**Subject: Request for Approval of Class 1 Modification to the Los Alamos National Laboratory (LANL) Hazardous Waste Facility Permit, EPA ID # NM0890010515**

**Description of the Permit Modification and Proposed Permit  
Changes**

## **Class 1 Permit Modification Request**

The purpose of this permit modification submittal is to add two structures (124B and 124C) inside of Dome 375. The structures consist of two Klinge Conex refrigeration units that are 480v 3 phase with dimensions for both units collectively of 20-ft long x 8-ft wide x 8.5-ft high. The structures will be co-located adjacent to the roll-up door opening for the modular containment structure (box process area) within Dome 375, which is located on Pad 11, at TA-54, Area G. The doors for each unit will be facing into the box process area. Stainless steel panels, similar to the Permacon will join the two structures and the 375 box process area to integrate the gap between the structures and the roll-up door opening. This will the HEPA filtration capability of the box process area ventilation system. The structures will be fully integrated into the box process area. The two units will be used for the storage of hazardo

Attachment G.12 – TA-54 Area G Pad 11 Outdoor Closure Plan

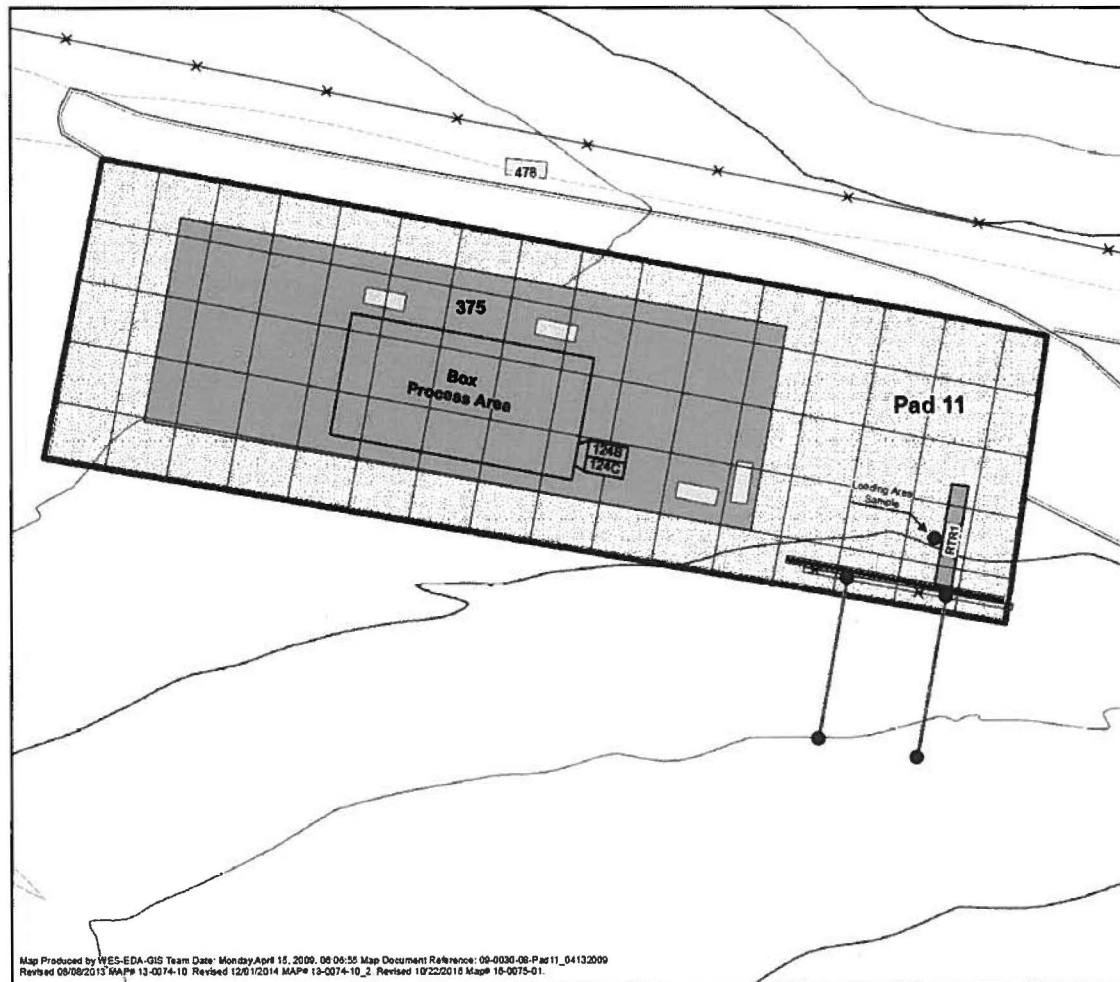
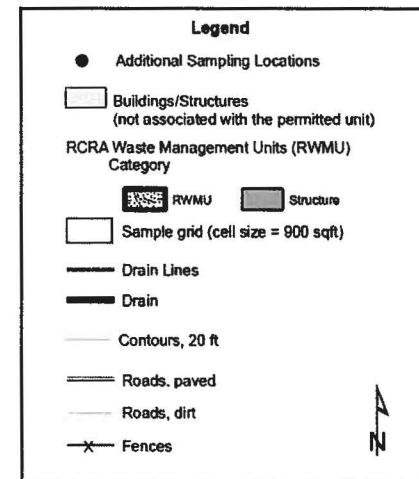
Figure 36, *TA-54, Area G, Pad 11* and Figure G.12, *Technical Area 54, Area G, Pad 11 Outdoor Closure Plan*, were revised to include the location of both the Klinge Conex units.

The permitted unit stores hazardous waste in both liquid and solid form in Dome 375. The dome, which is an aluminum framework of trusses covered with tension-fitted ultraviolet resistant, fire-retardant coated, polyester fabric, is 300 feet long by 100 feet wide and covers a surface area of approximately 30,000 square feet. It is anchored with anchor bolts to the interior concrete ring wall and is equipped with two double-panel rolling doors, one at the east end of the dome and the other on the west end. It also has 14 personnel doors located approximately every 31 to 57 feet along the dome's length. These doors allow for adequate access both by vehicles and by personnel. The interior perimeter of the dome is surrounded by a concrete ring wall, which helps prevent run-on into and runoff from the dome. Asphalt ramps located at the vehicle entrances allow vehicles and container handling equipment to pass safely over the curb. Dome 375 contains a modular panel containment structure (approximately 120 feet long x 60 feet wide) used for size reduction, decontamination, segregation, waste assay, reclassification activities, and repackaging of transuranic waste prior to shipment offsite. Two structures (124B and 124C) are connected to the modular panel containment structure. The external dimensions of the structures are approximately 20 feet ft long, 8 ft wide and 8.5 ft high. The structures are refrigeration units,

electrically driven, and are constructed of stainless steel internal and external panels. The structures are connected to the roll up-door opening for the modular containment structure, with the doors for each of the units facing into the modular containment structure.
